**ADDENDUM FOR
TENDER NO: MOICT/SDICT/ONT/008/2021-2022**

**TENDER FOR SUPPLY, INSTALLATION AND COMMISSIONING OF
NETWORK INFRASTRUCTURE
AT KITUI LEVEL IV COUNTY HOSPITAL, KITUI COUNTY**

ISSUE DATE: 23RD AUGUST, 2021

KITUI REFERRAL HOSPITAL
Kitchen/Catering office
Proposed Network Layout

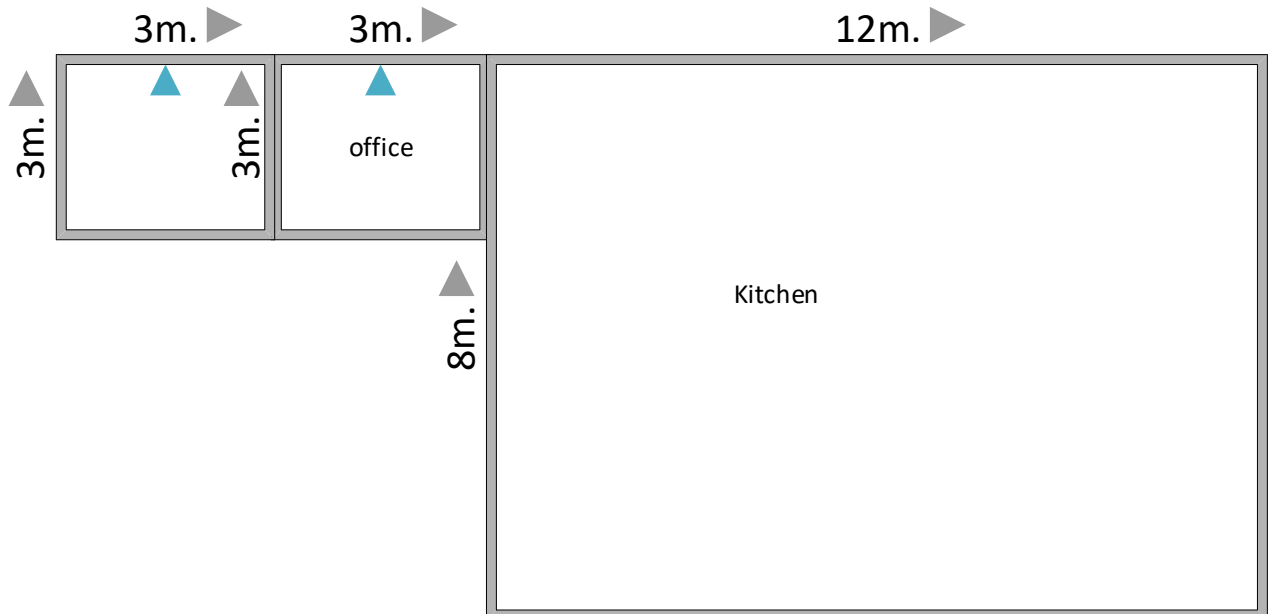
No.	ISSUES THAT CAME UP	CLARIFICATION
1.	The following service points/blocks were not included in the tender document namely; <ul style="list-style-type: none"> • CHMT Block • Manufacturing • Catering office • 2- pay points • New Doctor block 	The Bill of Materials, Price Schedule and network designs have been amended to accordingly to reflect the new requirements as specified in section 3.0, 4.0 and 5.0 of this Addendum.
